NEW BERN STATION AREA PLAN

Plan Amendments
Draft October 2017

Rail Frontage / Multi-Use Trail

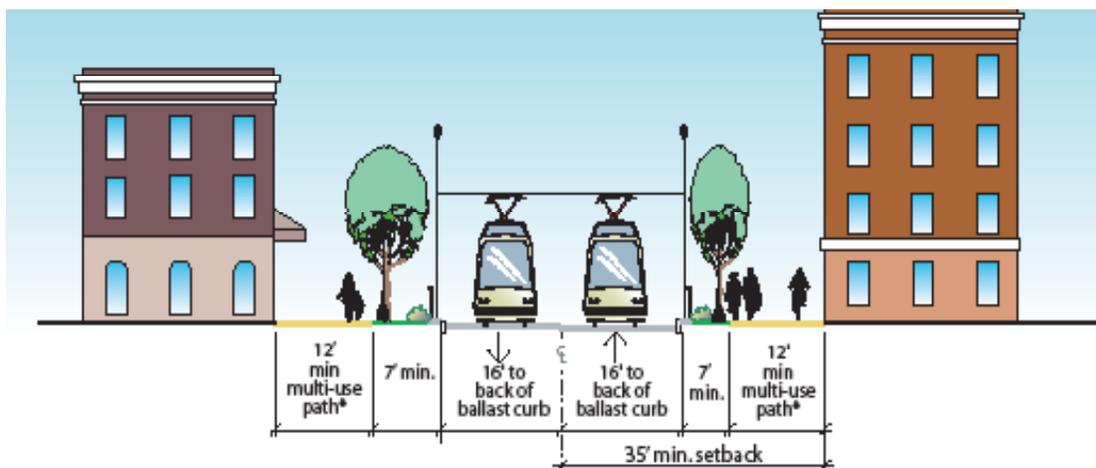
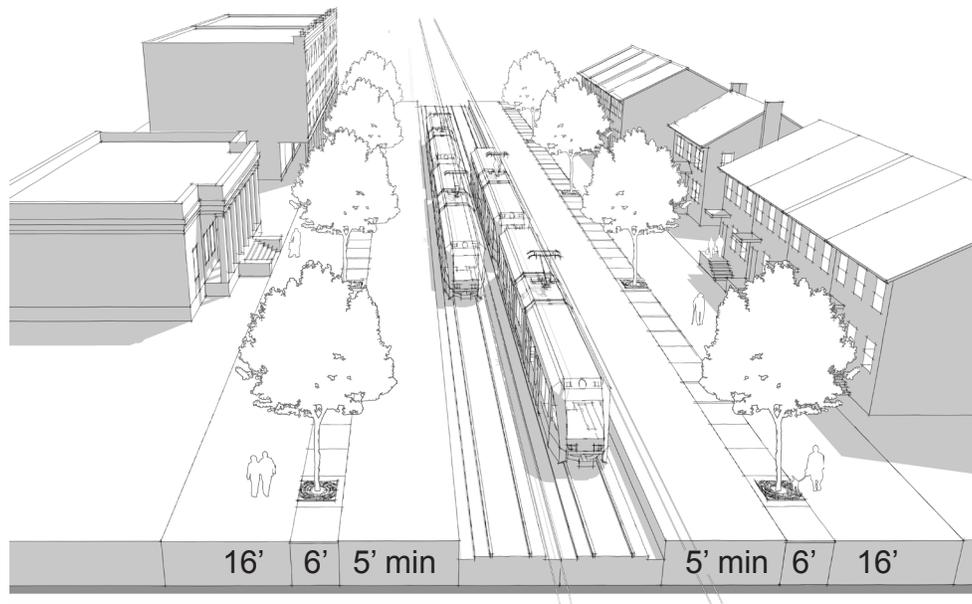
- A minimum of 7 feet outward from the ballast curb is reserved for a landscaped buffer to the track. Tree planting is required with spacing, irrigation, subdrainage, and adequate soil space for roots. Trees must be a columnar form, planted a minimum of 5 feet out from the ballast curb, and approved by CATS. Tree spacing should be consistent with spacing for street trees, as required by the Charlotte Tree Ordinance.

- The multi-use trail, a minimum of 12 feet wide, should be constructed beyond the landscaped buffer. If there is an existing asphalt trail, it should be replaced by an enhanced trail. The trail location may be required to be more than 7 feet from the back of the ballast curb due to site features such as topography, drainage, and CATS equipment. The location of this trail must be approved by CATS. The trail material must be approved by Planning and CDOT. The trail can be widened to allow emergency fire access, but should not be used as a driveway for adjacent development.

- A minimum of 5 feet outward from the ballast curb is reserved for a landscaped buffer to the track. Tree planting is required with spacing, irrigation, subdrainage, and adequate soil space for roots. Trees must be a columnar form, planted a minimum of 5 feet out from the ballast curb, and approved by CATS. Tree spacing should be consistent with spacing for street trees, as required by the Charlotte Tree Ordinance.

- The multi-use trail, a minimum of 16 feet wide, should be constructed beyond the landscaped buffer. If there is an existing asphalt trail, it should be replaced by an enhanced trail. The trail location may be required to be more than 7 feet from the back of the ballast curb due to site features such as topography, drainage, and CATS equipment. The location of this trail must be approved by CATS. The trail material must be approved by Planning and CDOT. The trail can be widened to allow emergency fire access, but should not be used as a driveway for adjacent development.
